## CANBY PLANNING COMMISSION

SUB 90-06, an application by A. Wayne Scott for approval of Phase II of Willow Creek Estates. Forty-nine single family units are proposed with over 6 acres of greenway, including wetlands and a recreational area. A portion of the site lies in the Hazard Overlay Zone. The site is located northwest of 99E, south of N.E. Territorial, and east of Redwood. [Phase I, consisting of 50 single family lots was previously approved by the Commission. The applicant has submitted new information involving wetlands, traffic impact analysis and noise abatement.] (Tax Lot 500 of Tax Map 3-1E-27DB, Tax Lots 700 and 900 of Tax Map 3-1E-27C, and Tax Lot 800 of Tax Map 3-1E-27C.)

- M E M O -

**RE:** Supplemental Staff Report - Willow Creek [SUB 90-06]  
[Previously Teakwood Terrace]

**FIGURE 3**

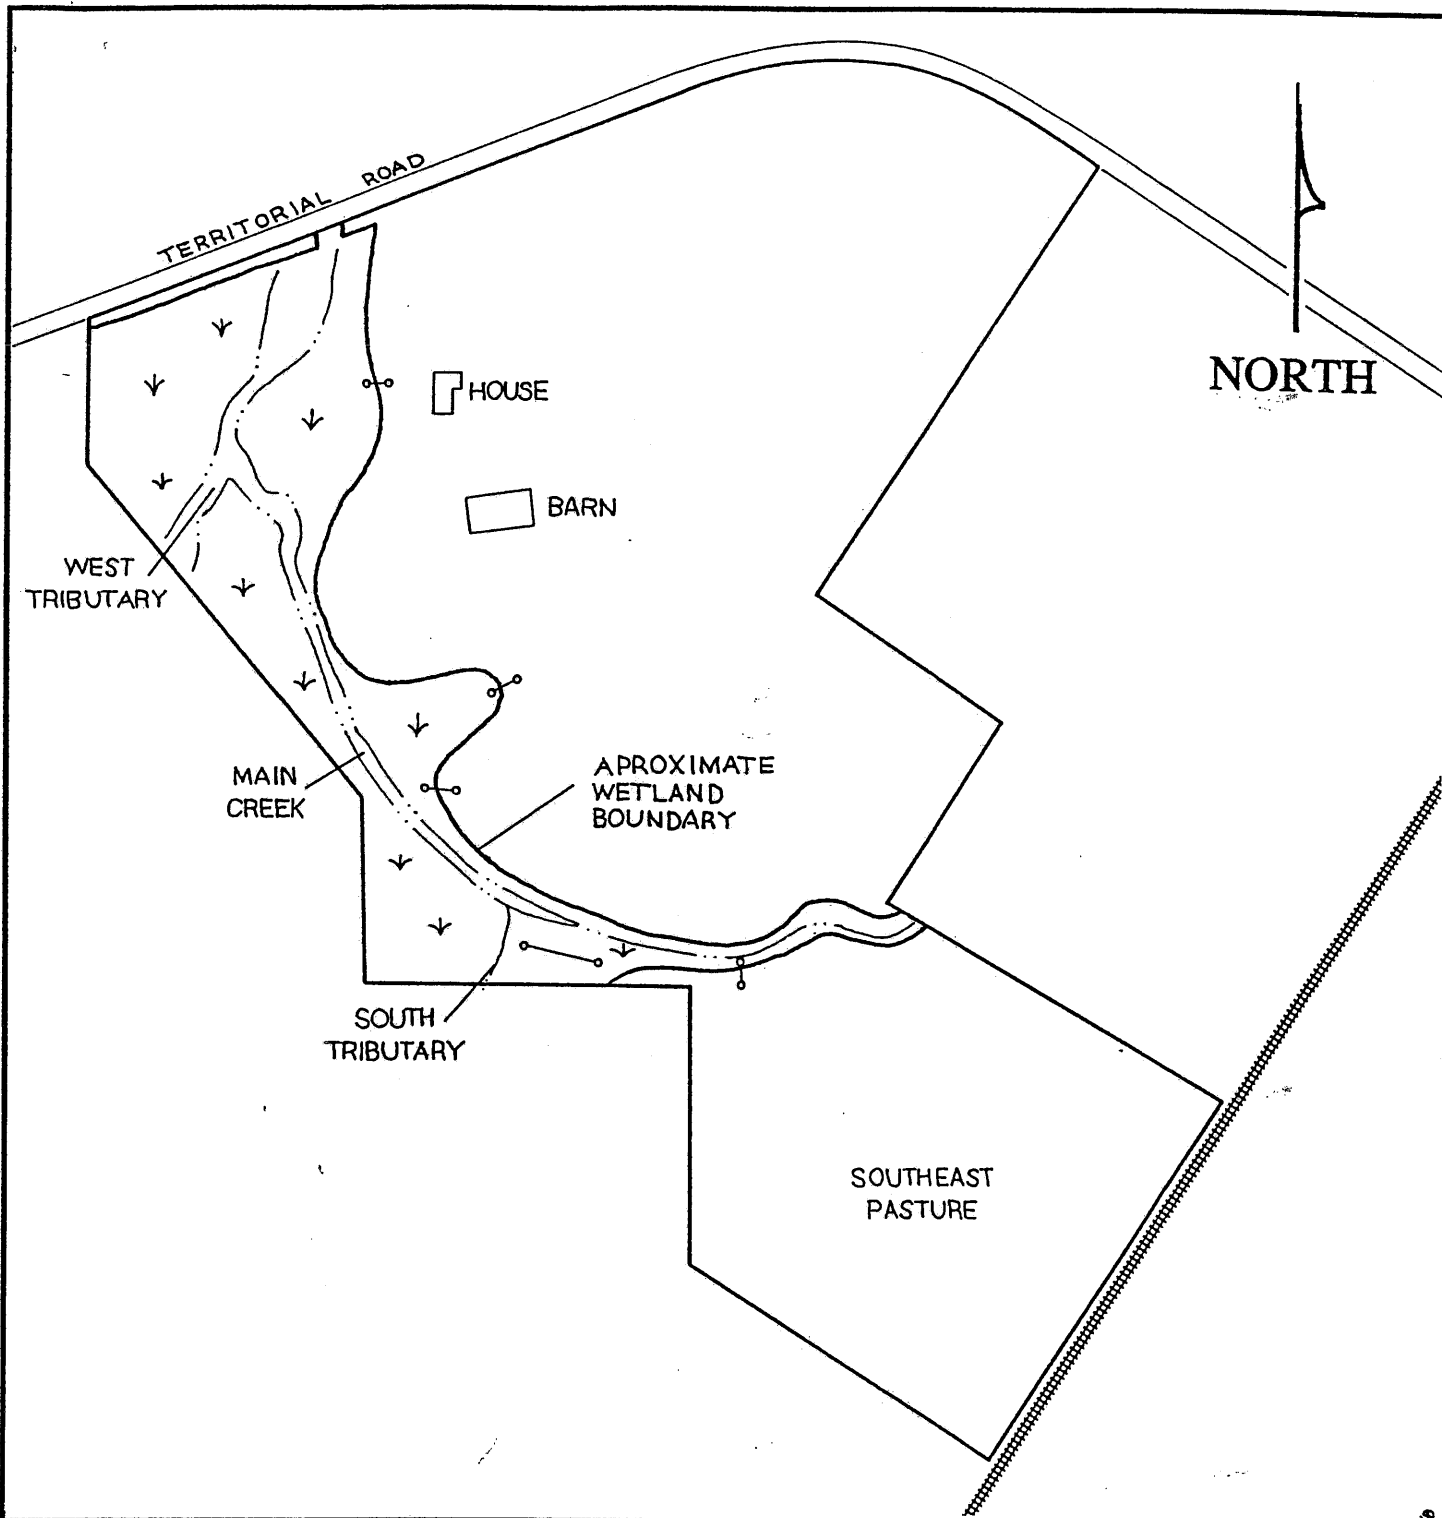
on the adjacent property and minimize impact on the subject property. The wetlands report does not make any proposals about type of treatment for the wetlands area. The map, Figure 3, submitted with the study by the Wetlands Consultant, illustrates an "approximate wetland boundary." It also states that approximately 6 acres of wetlands were "flagged" during the field study. Presumably, it is this "flagged" area which is shown on the "Revised Phase 2 Tentative Plat" as the "wetlands boundary." The only improvement within the wetlands area on the tentative plat appears to be one edge of the proposed tennis court and the stream crossing of the new Teakwood Drive alignment. On page 7 of the Wetland Report, it states that "Wetland functions and values of the Willow Creek Estates site were evaluated and determined to have low to moderate value for wildlife habitat, sediment trapping, flood storage/desynchronization for on- and off-site runoff and groundwater modification, passive recreation, and food chain support. The remaining wetland values and functions reviewed in the evaluation process, including active recreation, endangered species habitat, unique/rare wetland, fisheries habitat, nutrient retention removal, and shoreline stabilization, have low or no functional value." Since this area is within a Hazard Overlay Zone, the Commission will need to consider conditions related to this designation.

21. The wetlands report, as submitted with the revised application, is accepted as a preliminary wetlands boundary determination provided that, prior to approval of the final plat, a final report is prepared by a recognized wetlands/wildlife habitat expert(s). Such report(s) shall include a final wetlands determination and delineation. Wildlife habitat preservation and enhancement recommendations and stream corridor protection recommendations shall be included and any needed mitigation procedures shall be described and shall include recommended buffer zones or open space development around all streams on the entire site, ponds and wetlands, and shall provide restrictive covenants that prevent mowing and removal of desirable wildlife plants. The applicant shall submit his wetlands report and wetlands determination to the Division of State Lands for acceptance of such determination. The action of the Division of State Lands shall be provided to the Canby Planning Director for review and approval for consistency with this approval
